Comment Agenda

162 cable assembly

162A-D Annexes

Chris DiMinico
MC Communications/PHY-SI LLC/Panduit
cdiminico@ieee.org

#71 haser_3ck_adhoc_02_061720.pdf

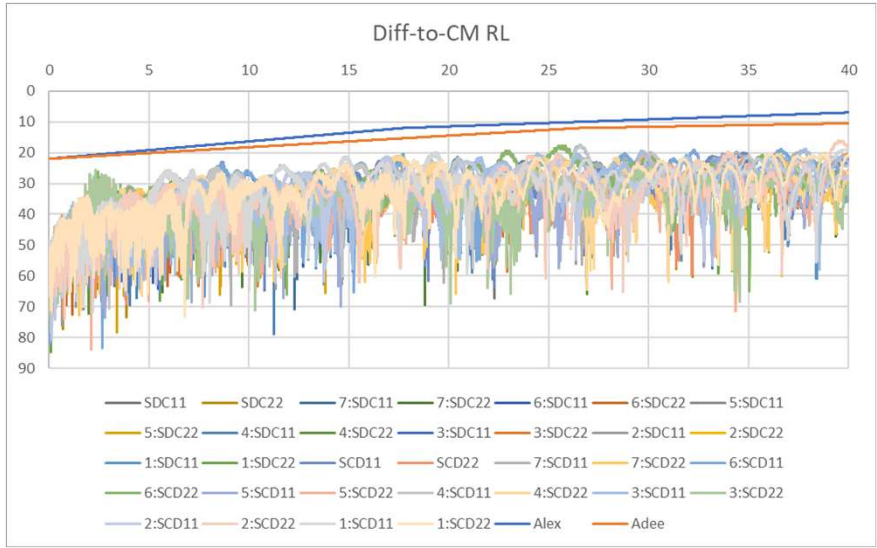
Differential to Common-Mode Return Loss:

802.3ck proposal:

$$\left(22 - \frac{15}{26.56}f\right) \text{ dB} \quad 0.05 \text{ GHz} \leq f < 17.7 \text{ GHz}$$

$$\left(16 - \frac{6}{26.56}f\right) \text{ dB} \quad 17.7 \text{ GHz} \leq f \leq 40 \text{ GHz}$$

Alex # 71 Adee - #147

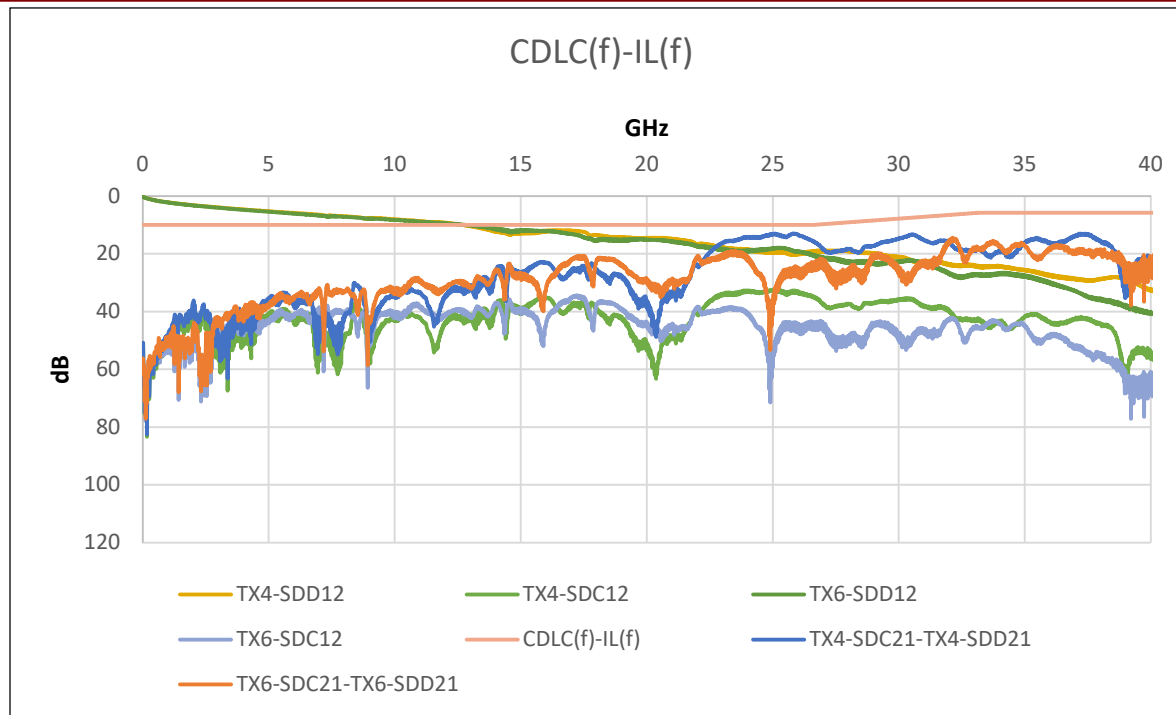
common to differential mode RL proposals

#147 ---CDRL(f) ≥
 $22 - 10 * f / f_N, 0.01 \leq f \leq f_N$
 $15 - 3 * f / f_N, f_N < f < 40$
 Where
 $f_N = 26.5625$ is the Nyquist frequency in GHz
 f is the frequency in GHz

CA CDCL – 148*, 74

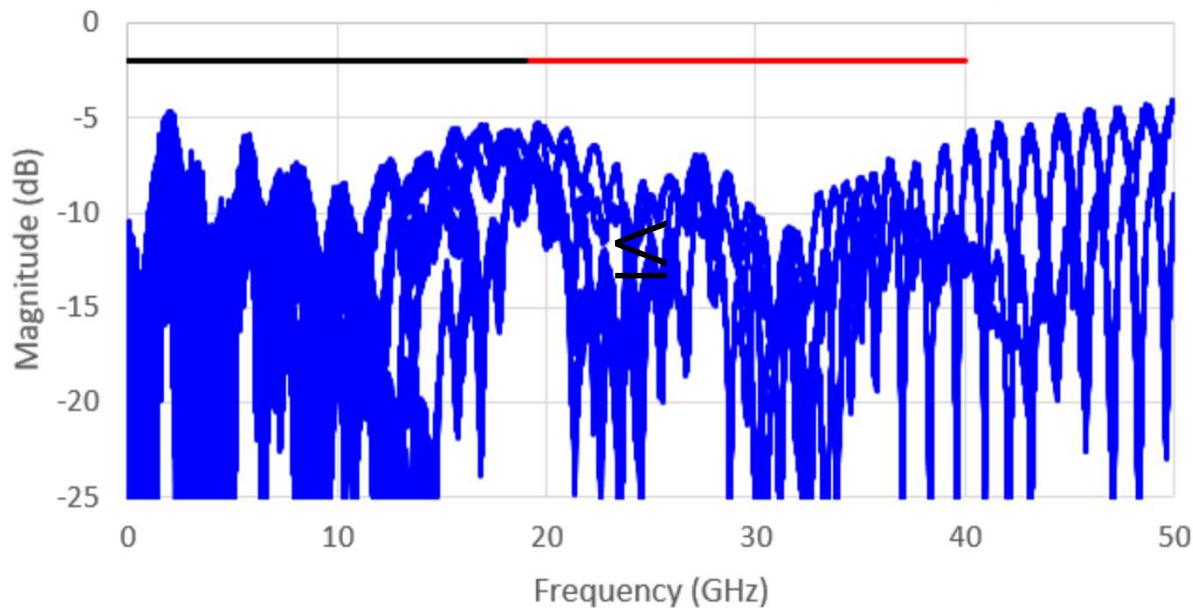
The difference between the cable assembly differential to common-mode conversion loss

assembly insertion loss shall meet Equation (162-new).

$$CDCL(f) - IL(f) \geq$$

$$10, 0.01 \leq f \leq f_N$$

$$27-17*f/f_N, f_N < f \leq 1.25*f_N$$

$$5.75, 1.25*f_N < f < 40$$

Figure 92A-1—Insertion Loss Tx or Rx PCB max and min

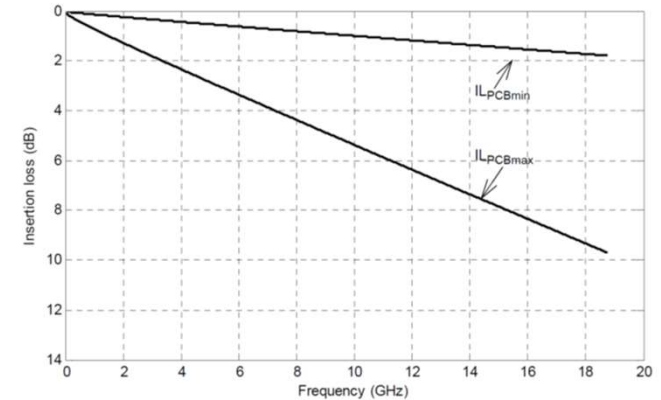
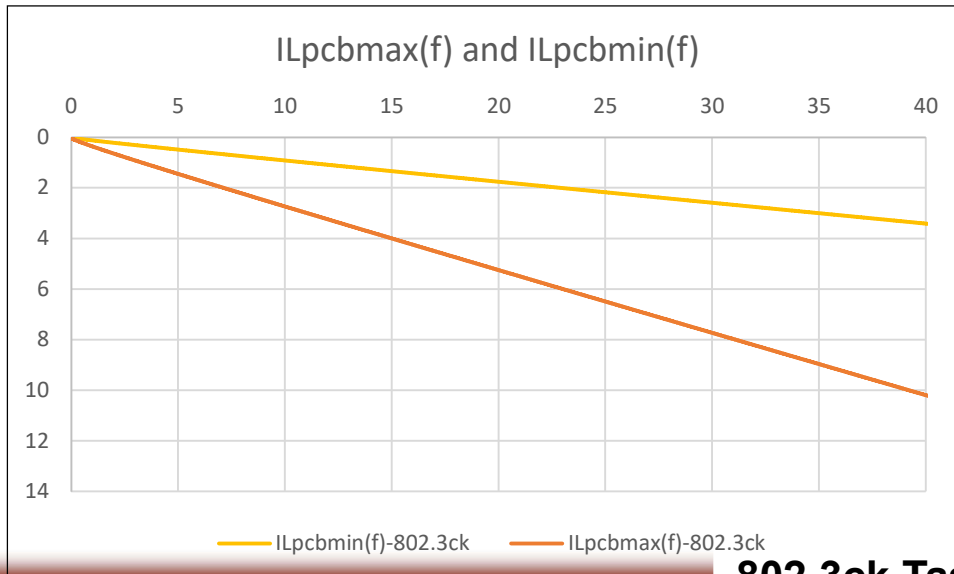
The recommended maximum and minimum printed circuit board trace insertion losses are specified in **TBD** and **TBD**, respectively.

Note that the recommended maximum insertion loss allocation for the transmitter or receiver differential controlled impedance printed circuit boards with allowances for ball grid array (BGA) footprint and host connector footprints is 6.875 dB at 26.56 GHz and the recommended minimum insertion loss allocation for the transmitter or receiver differential controlled impedance printed circuit boards is 2.3 dB at 26.56 GHz. The recommended maximum insertion loss allocation for the transmitter or receiver differential controlled impedance printed circuit boards is consistent with the insertion loss from TP0 to TP2 or TP3 to TP5 given in **TBD** and an assumed mated connector loss of 1.6 dB.

$$IL_{pcbmax}(f) = 0.0176 + 0.1082 \cdot \sqrt{f} + 0.2372 \cdot f$$

$$IL_{pcbmin}(f) = 0.0059 + 0.0361 \cdot \sqrt{f} + 0.0794 \cdot f$$

Editorial license update Annex reference to 162.11.2 ILCamin

#180 - MTF Differential Return Loss

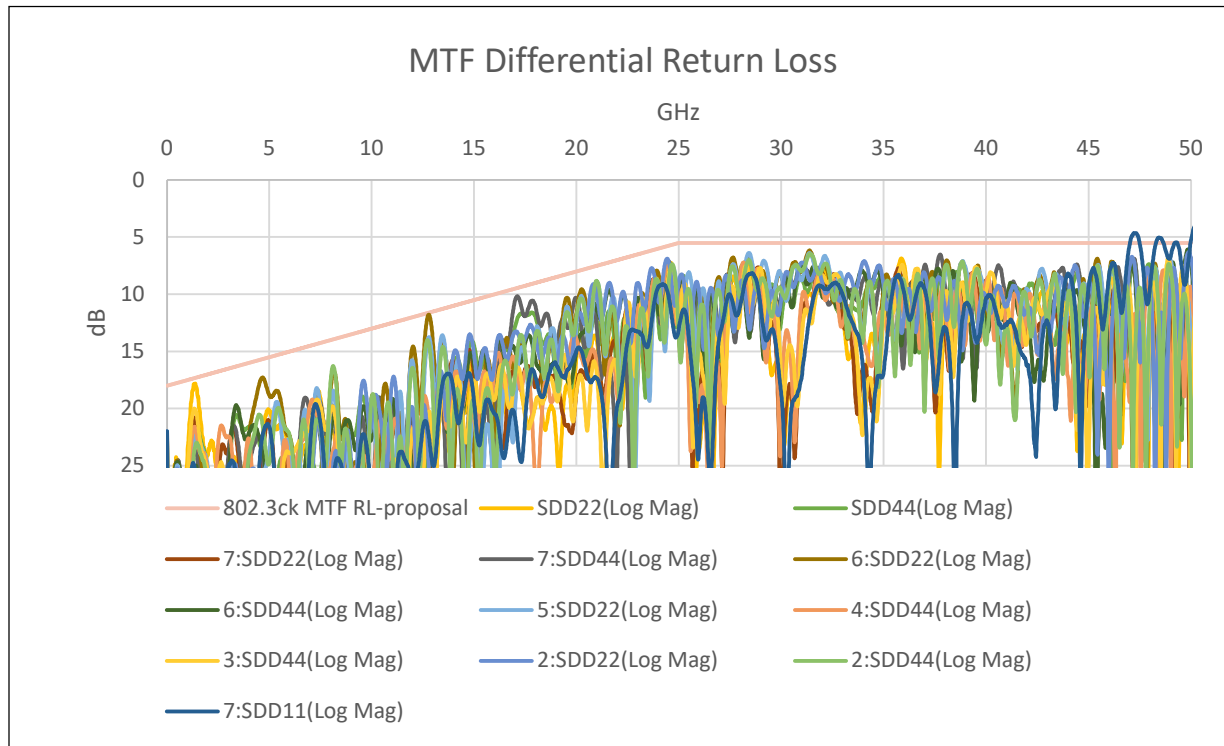
#86,#87 - 162B.1.3.2 Mated test fixtures - **RL (TBD)** - Change from $0.01 \text{ GHz} \leq f_{\text{GHz}} \leq 50 \text{ GHz}$ to $0.05 \text{ GHz} \leq f_{\text{GHz}} \leq 40 \text{ GHz}$ and update figure.

PROPOSAL: Differential Return Loss =

$18 - 0.5 * f_{\text{GHz}}$ $0.05 \text{ GHz} \leq f_{\text{GHz}} < 25 \text{ GHz}$

5.5 $25 \text{ GHz} \leq f_{\text{GHz}} \leq 40 \text{ GHz}$

#86,87 - MTF Differential Return Loss

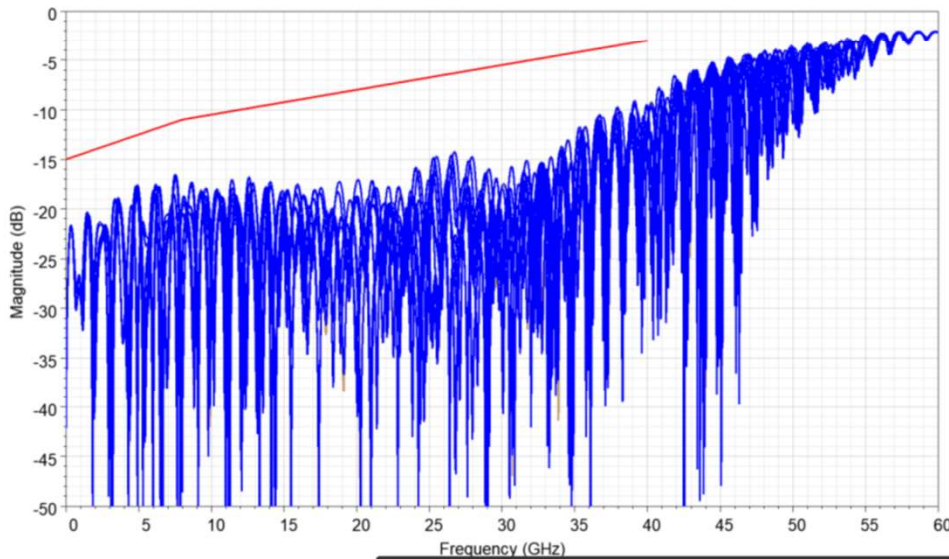
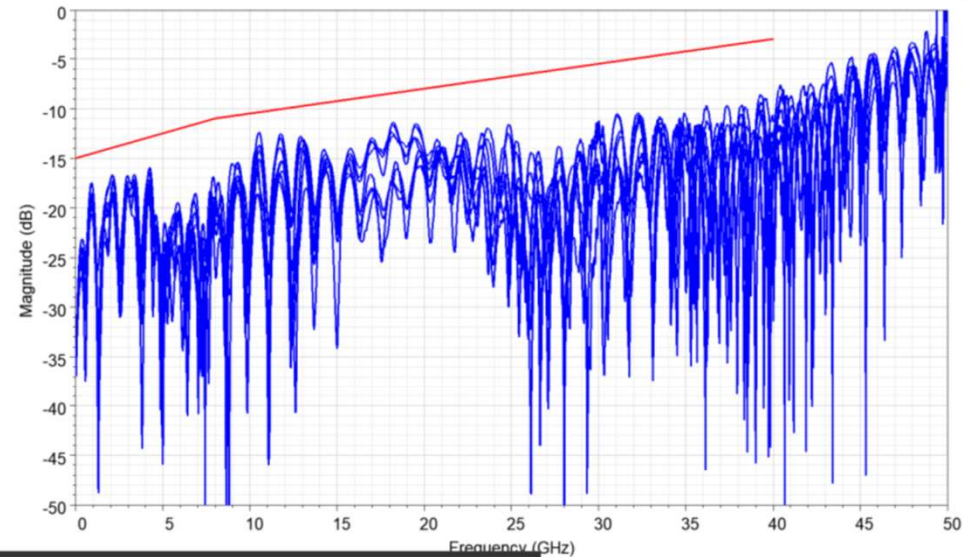
#86,#87 - 162B.1.3.2 Mated test fixtures - **RL (TBD)** - Change from 0.01 GHz $\leq f_{\text{GHz}} \leq 50$ GHz to **0.05 GHz $\leq f_{\text{GHz}} \leq 40$ GHz** and update figure.

NOTE: 802.3ck D1.2 does not include a limit line for this parameter

Proposal: $15 - 0.5f$ $f < 8 \text{ GHz}$
 $13 - 0.25f$ $8 \text{ GHz} \leq f \leq 40 \text{ GHz}$

#180- MTF Common Mode Conversion Loss

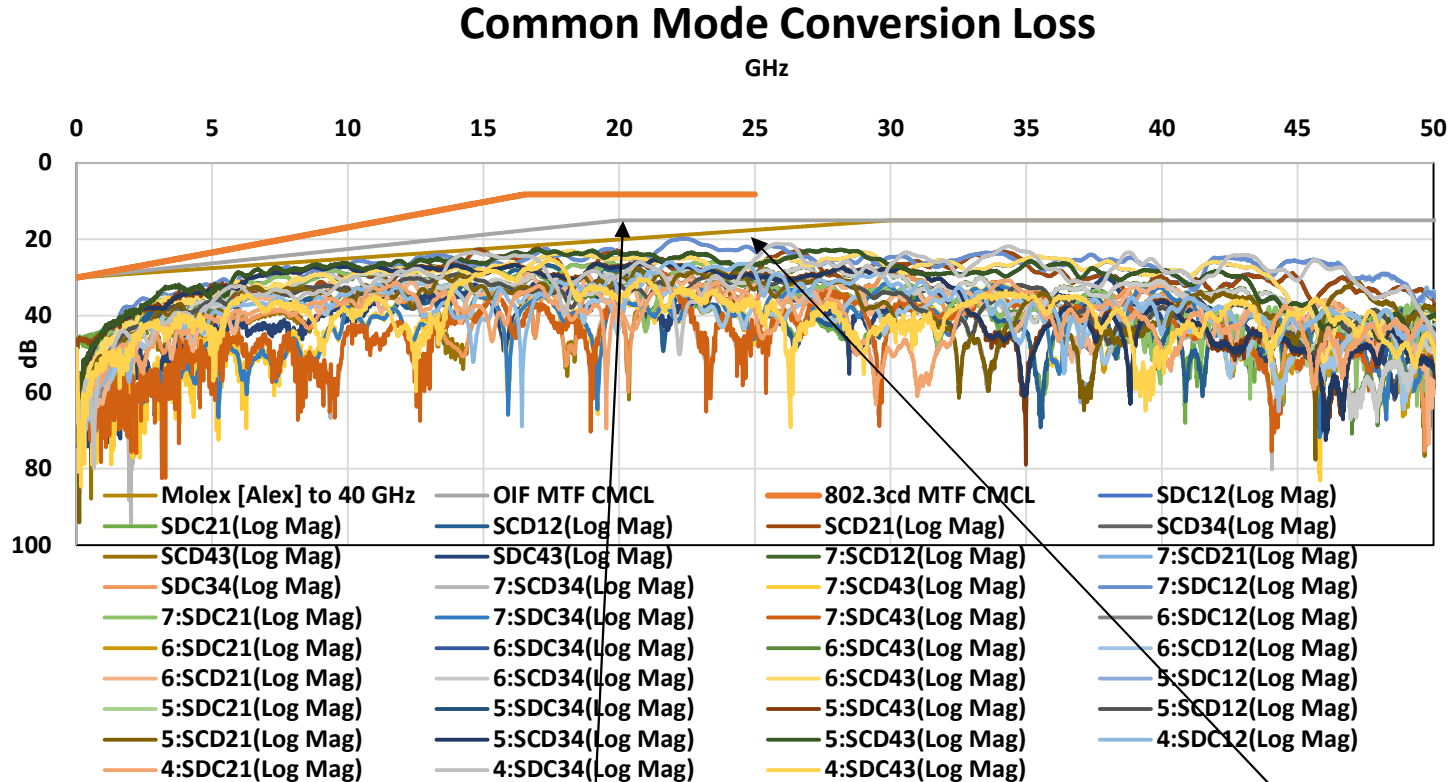
#88,#89 - 162B.1.3.4 Mated test fixtures - **CMCIL (TBD)** - Change from $0.01 \text{ GHz} \leq f_{\text{GHz}} \leq 50 \text{ GHz}$ to $0.05 \text{ GHz} \leq f_{\text{GHz}} \leq 40 \text{ GHz}$ and update figure.

PROPOSAL: Common Mode Conversion Loss =

$30 - (21/28) * f_{\text{GHz}}$ $0.05 \text{ TBD GHz} \leq f_{\text{GHz}} < 20 \text{ GHz}$

15 $20 \text{ GHz} \leq f_{\text{GHz}} \leq 40 \text{ GHz}$

#88,#89 -162B.1.3.4 Mated test fixtures - CMCIL

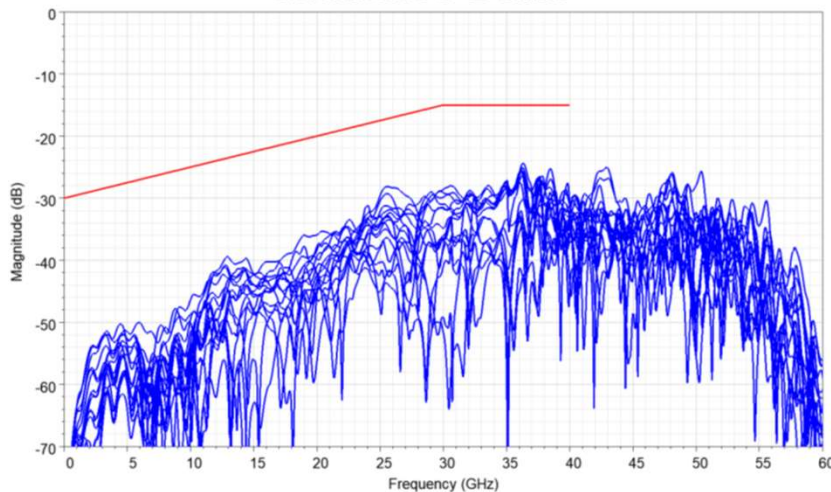
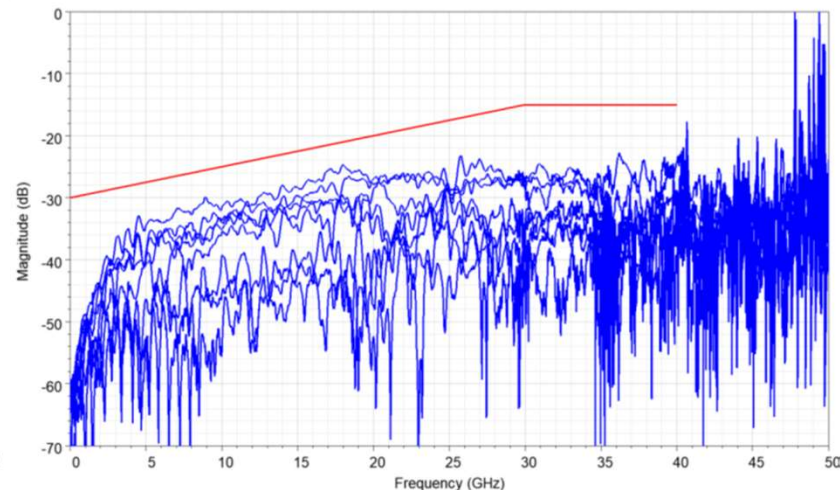
#88,#89 - 162B.1.3.4 Mated test fixtures - **CMCIL (TBD)** - Change from $0.01 \text{ GHz} \leq f_{\text{GHz}} \leq 50 \text{ GHz}$ to $0.05 \text{ GHz} \leq f_{\text{GHz}} \leq 40 \text{ GHz}$ and update figure.

NOTE: 802.3ck D1.2 does not include a limit line for this parameter

Proposal:	$30 - 0.5f$	$f < 30 \text{ GHz}$
	15	$30 \text{ GHz} \leq f \leq 40 \text{ GHz}$

IL Frequency range Max – 79, 80, 81,82

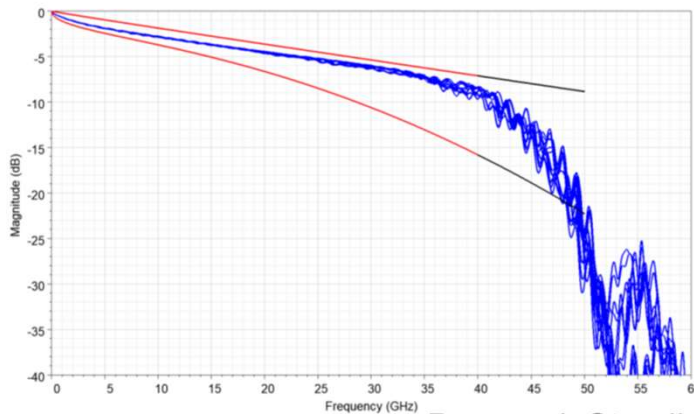
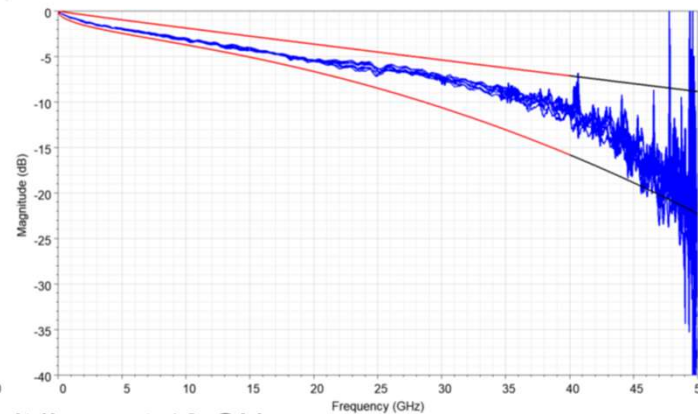
#79- 162B.1.1.1 Reference IL - Change from $0.01 \text{ GHz} \leq f_{\text{GHz}} \leq 50 \text{ GHz}$ to $0.05 \text{ GHz} \leq f_{\text{GHz}} \leq 40 \text{ GHz}$ and update figure.

#80- 162B.1.2.1 Cable assembly test fixture reference IL - Change from $0.01 \text{ GHz} \leq f_{\text{GHz}} \leq 50 \text{ GHz}$ to $0.05 \text{ GHz} \leq f_{\text{GHz}} \leq 40 \text{ GHz}$ and update figure.

#81,#82- 162B.1.3.1 Mated test fixtures max and min IL - Change from $0.01 \text{ GHz} \leq f_{\text{GHz}} \leq 50 \text{ GHz}$ to $0.05 \text{ GHz} \leq f_{\text{GHz}} \leq 40 \text{ GHz}$ and update figure.

Proposal: Stop limit lines at 40 GHz

#180 - Mated Test Fixture Specifications

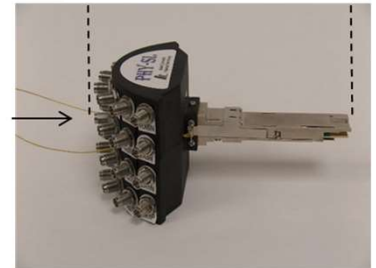
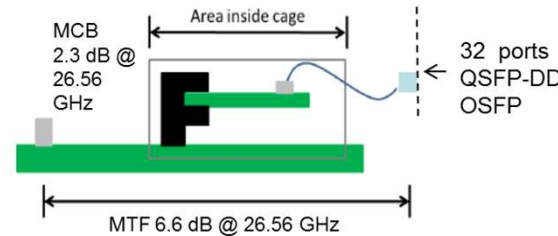
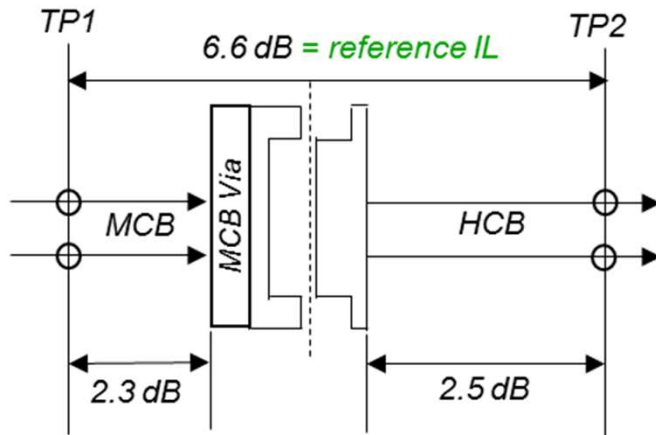
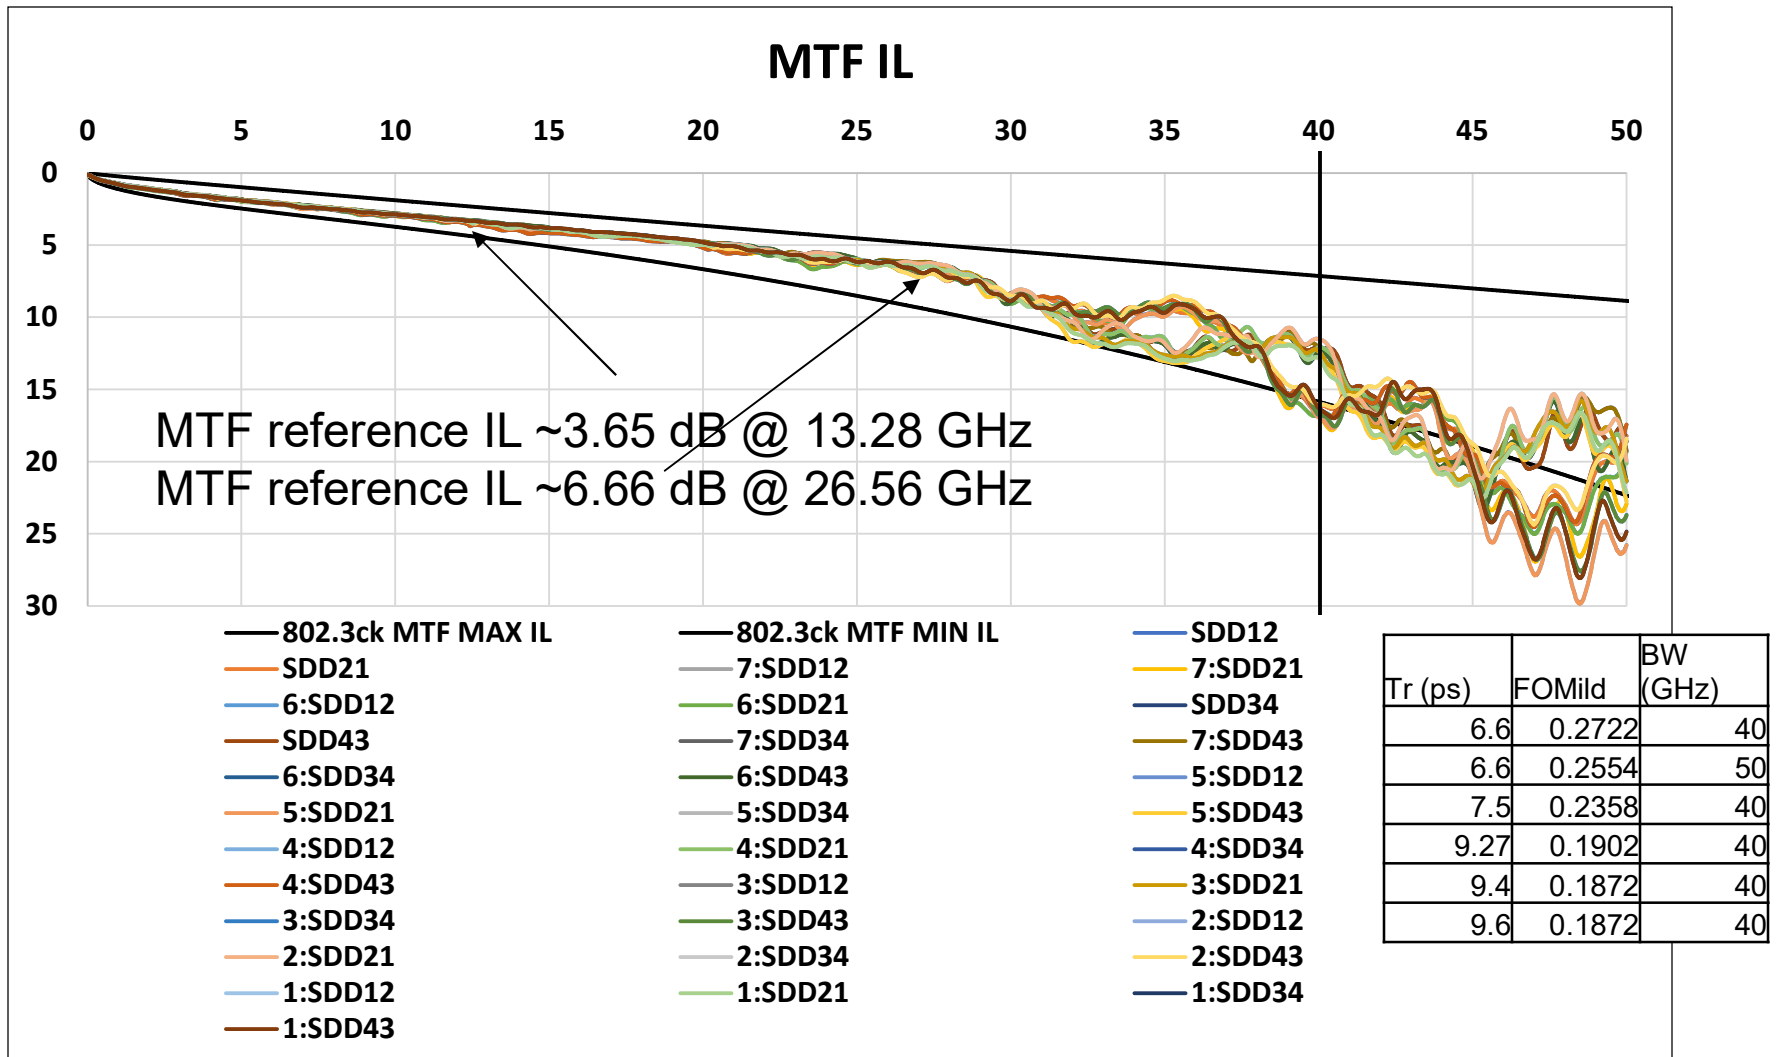
- Measurements with compliant PCB IL - HCB and MCB

Note: 2.3 dB MCB PCB includes test point IL
and MCB Via allowance is 0.2 dB

In support of IL Frequency range Max – 79, 80, 81,82
